RE: PR-2024-009765 SI 2023-00468 – Site Plan- EPC

### SI-2023-00468 – Site Plan EPC, Major Amendment

**RE: PR-2024-009765, SI-2024-00468  
SITE PLAN – EPC MAJOR AMENDMENT  
RESPONSE TO CONDITIONS OF APPROVAL  
TRACT A PLAT OF GATEWAY SUBDIVISION CONT 2.7845 AC  
IDO ZONE ATLAS PAGE J-15-Z**

Project # PR-2024-009765  
SI-2023-00468 – Site Plan – EPC, Major Amendment

LANDSCAPE  
PLAN

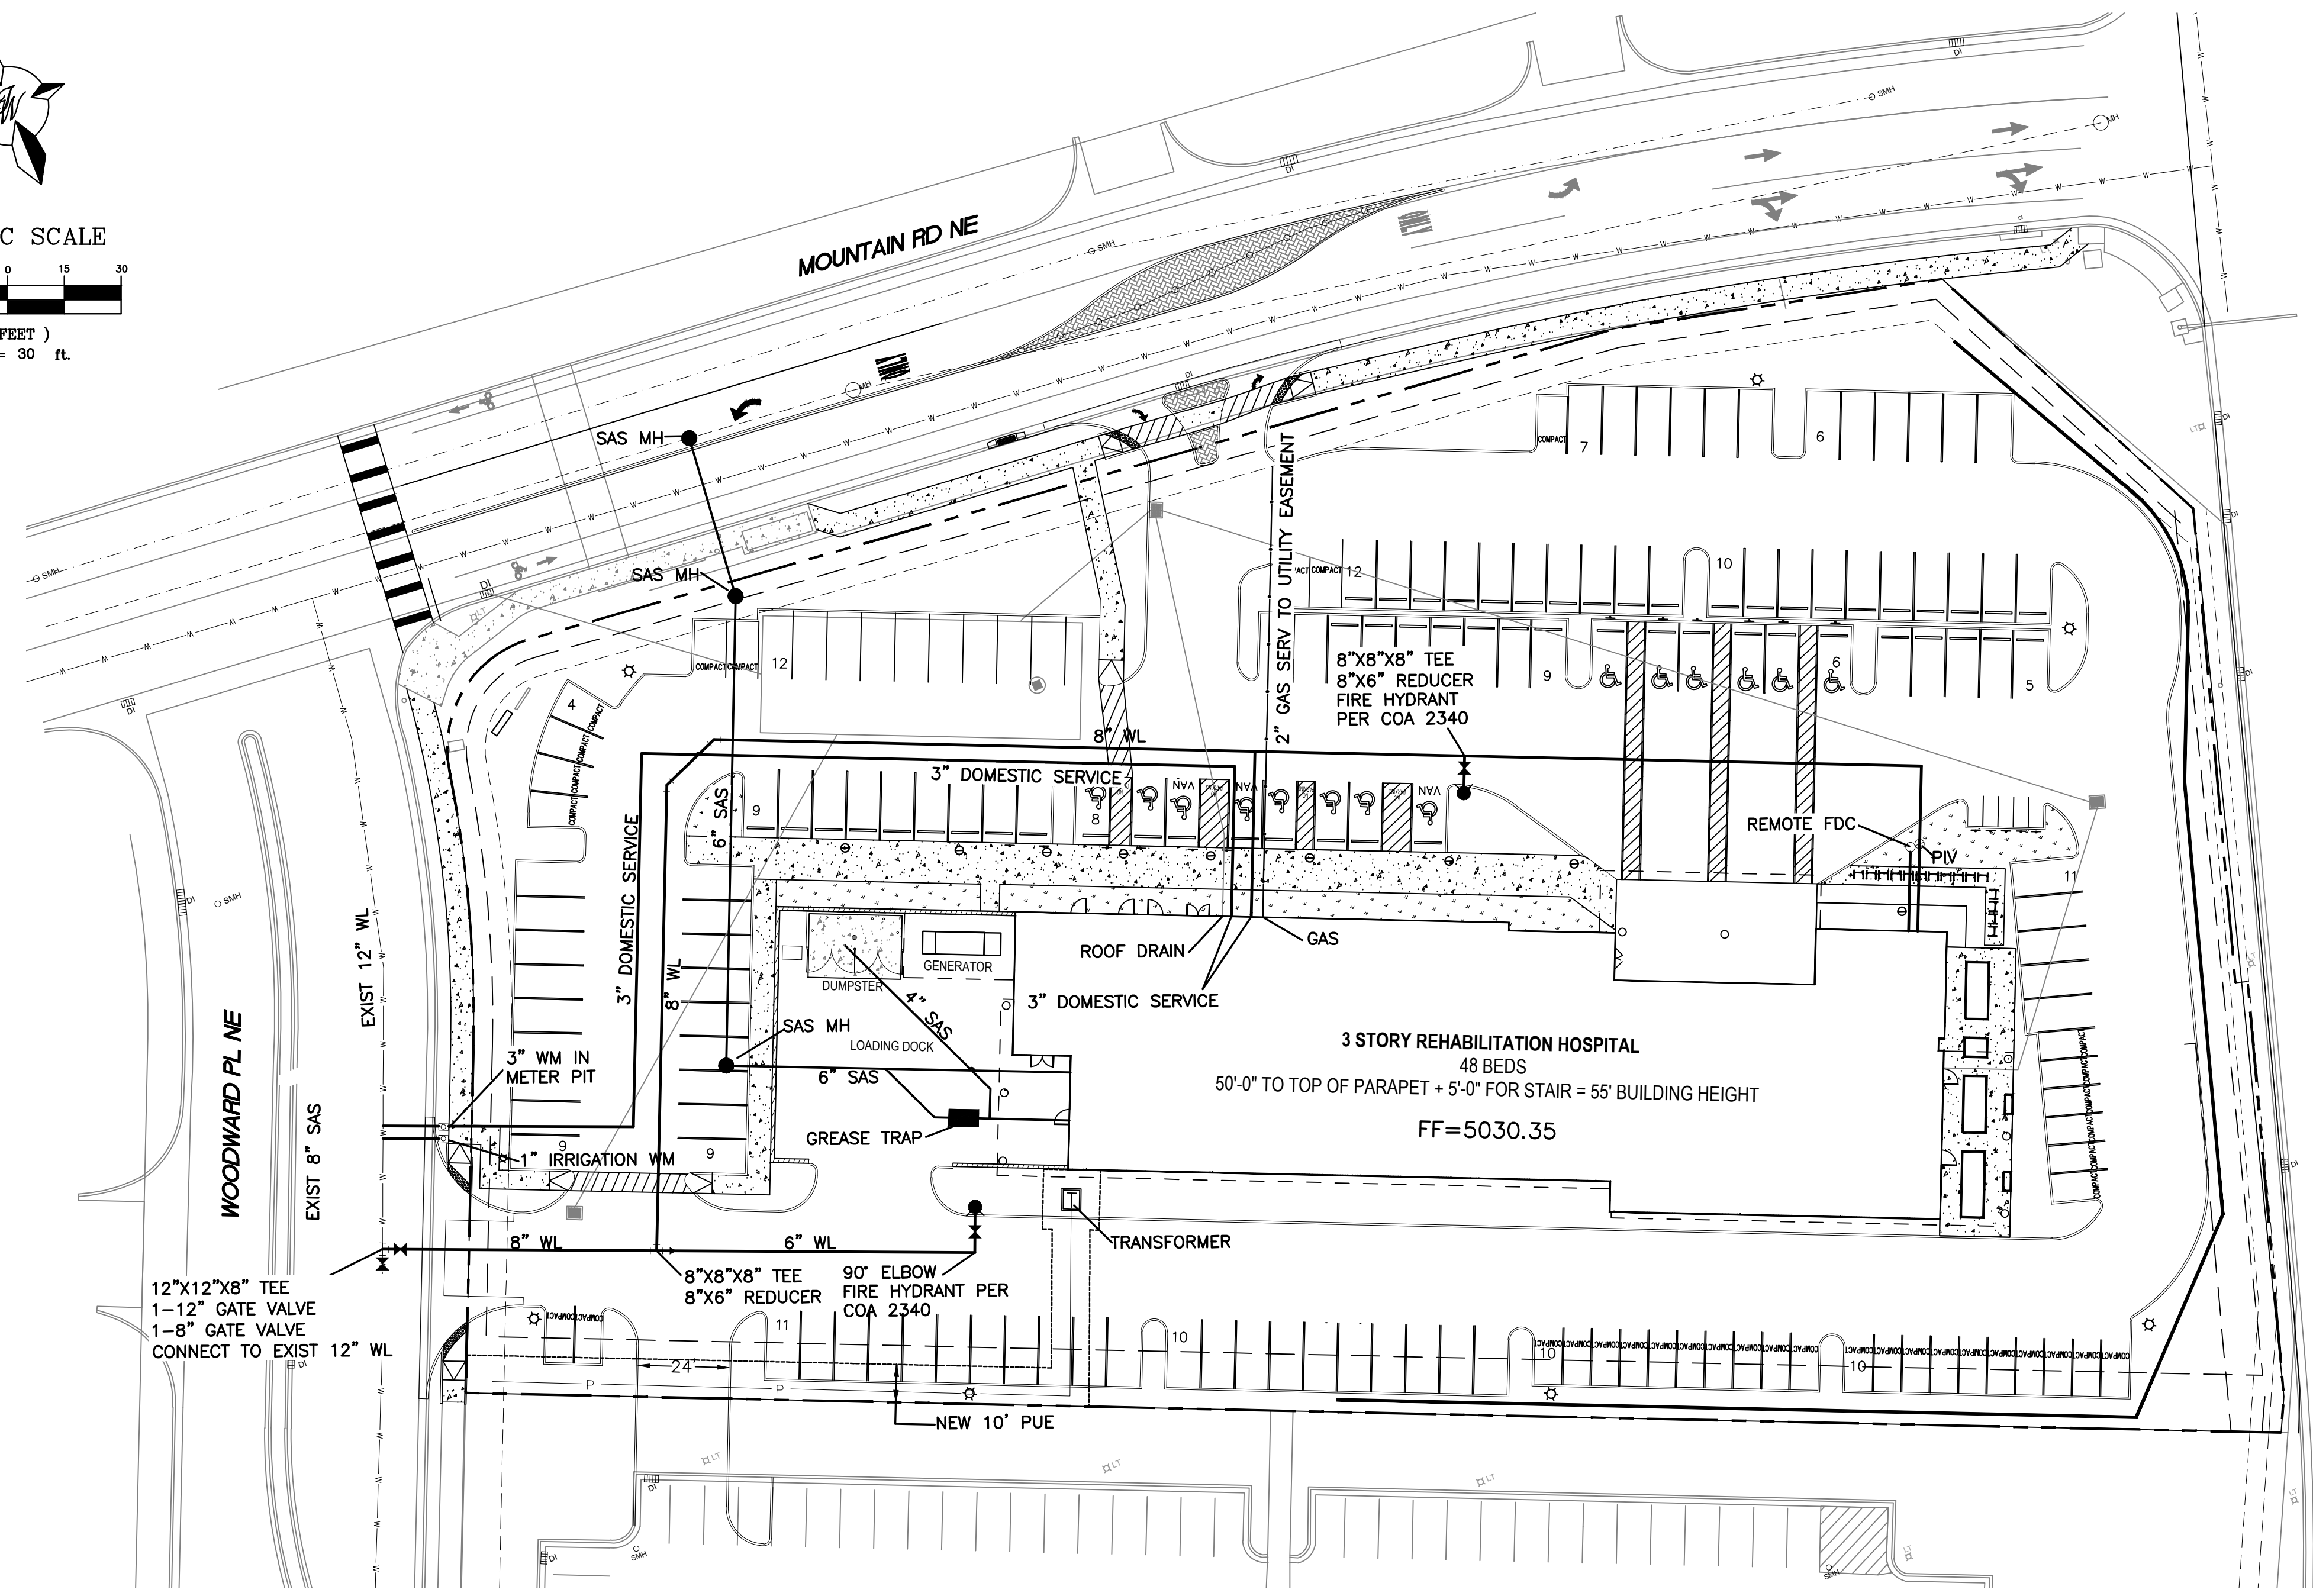
- A. The plan shall show all SF of planting beds and dimensions between trees on the Site Plan.  
***The area of the planting beds is shown on the plan. Street tree spacing calculations are shown next to the main entrance off Mountain Rd.***

- B. Boulders and landscape gravel types and amounts shall be provided.  
***The types and amounts are now shown on the Landscape Plan.***
- 7. Detail Sheet:
